Attachment E

PG&E's Comments on the North Fork Feather River Listing for Unknown Toxicity

WATER SEGMENT: North Fork Feather River below Lake Almanor (The proposed 2008 listing

Figure E-1. Water Segment Delineation and Actual Sampling Locations in the NFFR for DWR's Oroville Project (NFFR Downstream of Poe Powerhouse and Poe Powerhouse Discharge)

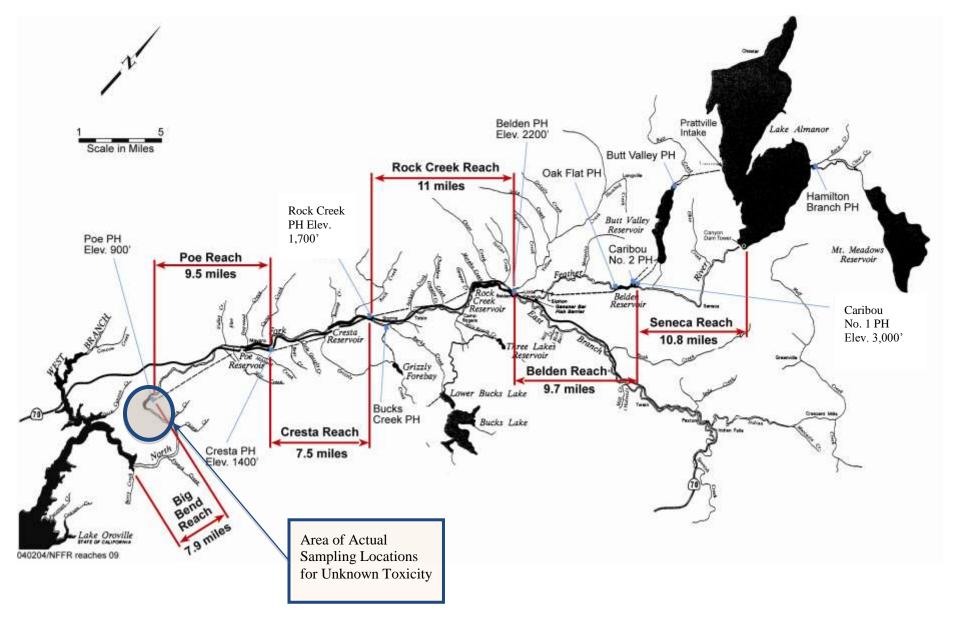
PG&E COMMENT: The CVRWQCB listed the entire NFFR below Lake Almanor in the Seneca

Reach through the Poe Reach to Lake Oroville due to exceedances of toxicity criteria, which only occurred only in samples collected from the NFFR in the

Big Bend Reach downstream of the Poe Powerhouse and at the Poe Powerhouse discharge point. Toxicity data are not available below Lake

Almanor through the Poe Reach upstream of Poe Powerhouse (a 48+ mile

stretch of river).

In addition, listing of water segments should be based upon the location of the available data, which in this case is from a location downstream of Poe Powerhouse and does not reflect potential water quality of the 48+ miles upstream. There is no evidence and therefore, no justification in favor of placing the NFFR below Lake Almanor through the Poe Reach above Poe Powerhouse on the section 303(d) list for impaired waterbodies.

PG&E has provided factsheets for each reach of the NFFR (Seneca, Belden, Rock Creek, Cresta, Poe, and Big Bend) in this submission. The following five fact sheets demonstrate that the Seneca, Belden, Rock Creek, Cresta, and Poe reaches should not be listed for unknown toxicity because no data is available to make a determination regarding listing. The last factsheet demonstrates that the only water segment with known available data that does show possible impairment for unknown toxicity (due to an unknown source) is the Big Bend Reach downstream of Poe Powerhouse and upstream of Lake Oroville.

RECOMMENDATION: Revise listing as follows: List the North Fork Feather River (NFFR) Big

Bend Reach only; do not list the remaining water segments of the NFFR.
